<h1>Parts Bulletin</h1>	Models	2011-2012 MY SONATA (YF)
		Parts Bulletin Number	PB001-19-01-011H
SUBJECT: Part Number Change for Recall Campaign 132 referencing TSB#: 19-01-011H. This Parts Bulletin is meant to be used only for Parts Update information only.		Date	April 25, 2019
		Area	USA
		Type	Parts Update Notification

Description: HMA is providing this Parts Bulletin to advise of the newly created reman part number information to the dealers as it relates to Recall Campaign 132.

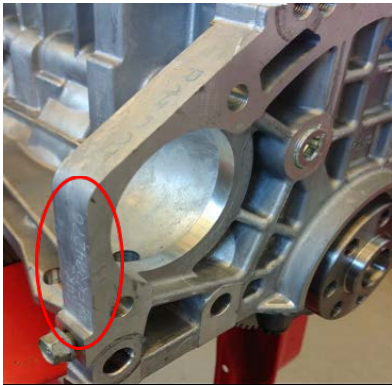
- Dealer should include the correct engine serial number and note it on the core return worksheet.
 - **It is necessary for the dealer to add the Serial Number as shown in the photo as a deduction would apply for missing serial number information:**
